**CITY OF SNELLVILLE
DEPARTMENT OF PLANNING & DEVELOPMENT
PLANNING COMMISSION**

CASE SUMMARY

CASE NUMBER:	RZ 25-05
REQUEST:	Rezoning and Request for Variances
LOCATION:	Tree Ln (Behind 12 Stone Church) 1719 Scenic Highway, Snellville, Georgia
SIZE:	15.01± Acres
TAX PARCEL:	5056 003
CURRENT ZONING:	BG (General Business) District
REQUESTED ZONING:	R-TH (Townhouse Residential) District
CURRENT FUTURE LAND PLAN:	Health Village
DEVELOPMENT/PROJECT:	108-Unit Single-Family (Attached) Townhome Development
PROPERTY OWNER:	Tree Lane Development, LLC Fishers, Indiana 46037
APPLICANT/CONTACT:	DeThomas Investments, LLC Robert "Jack" Wilson, Attorney for Applicant Lawrenceville, Georgia 30046 770-962-9780 JWilson@rjwpclaw.com
RECOMENDATION:	Approval with Conditions

June 5, 2025 Layout A Conceptual Site Plan

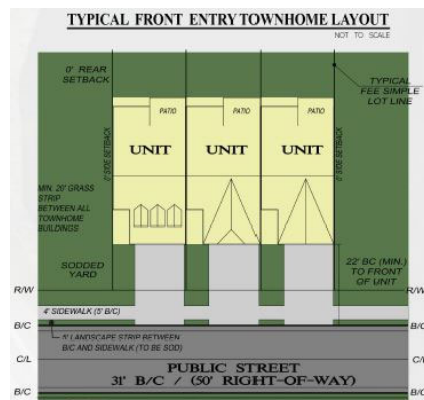
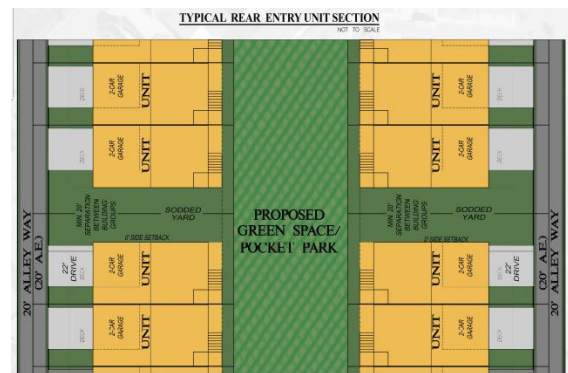
A proposed full-access driveway at Tree Ln serves as the sole ingress/egress point for the development with Street “A” and Street “B” serving as the main residential streets (31’ B.O.C./50’ R/W). With 20-foot wide Alley “A”, Alley “B”, and Alley “C” serving access to the rear-entry townhome units 1-72 and units 93-108. Front-entry townhome units 73-92 have direct access to Street “B”.

Pedestrian circulation for the rear-entry townhomes is provided by a 4-foot wide sidewalk and located adjacent to the 52-60 feet wide green space/pocket park areas. However, there is no sidewalk connectivity between the townhome units in front of the development to the remaining townhome units in the rear. Continuation of the sidewalks is encouraged to maximize pedestrian connectivity throughout the site.

Two stormwater management facilities are shown and located outside of the 50-foot stream buffer and 75-foot impervious surface setback which bisects the development. A mailbox kiosk is shown at Street “B”, located between unit 25 and unit 48. Ample guest/overflow parking is centrally located throughout the development providing 39 additional parking spaces, 12 spaces above the minimum 27 required spaces. A future recreational area is located at the western portion of the site.

Although not consistent with the driveway length requirement of the UDO requiring driveways to be a minimum of 22-feet in length, measured from the front of garage door to edge of sidewalk closest to garage, the site plan and typical front-entry townhome layout shows a 22-feet long driveway measured

from the front of the garage to Street “B” back-of-curb with the townhome layout showing a 4-

feet sidewalk with 5-foot landscape strip between the curb and sidewalk. This reduces the minimum required 22-foot setback between the garage door and sidewalk to 13-feet, resulting in the sidewalk being blocked by parked vehicles and thus making the sidewalk useless to residents and guests of the community. Elimination of the sidewalk along the front-entry units (73-92) would eliminate the conflict (see Condition #4).

Although not required by the UDO, a 25-foot *undisturbed buffer* is shown on the site plan (however shown as a 25-foot *graded and replanted buffer* on the colored conceptual plan) where the development site abuts residential uses to the west and extends eastward 350± feet along the southern property line.

4. In lieu of sidewalks required by the code on both sides of Street "A" and Street "B", a minimum 4-foot wide sidewalk with minimum 5-foot wide planter strip shall be installed as shown on the site plan for Street "B", with continuation of sidewalk and planter strip along Street "B" between Unit 72 and Unit 108, with sidewalk connection to the existing sidewalk at Tree Ln, with continuation of the Tree Ln sidewalk 150± feet to the west. To allow for the 22-foot minimum driveway length measured from garage door to Street "B" back-of-curb for front-entry Units 73-92, no sidewalk is required.
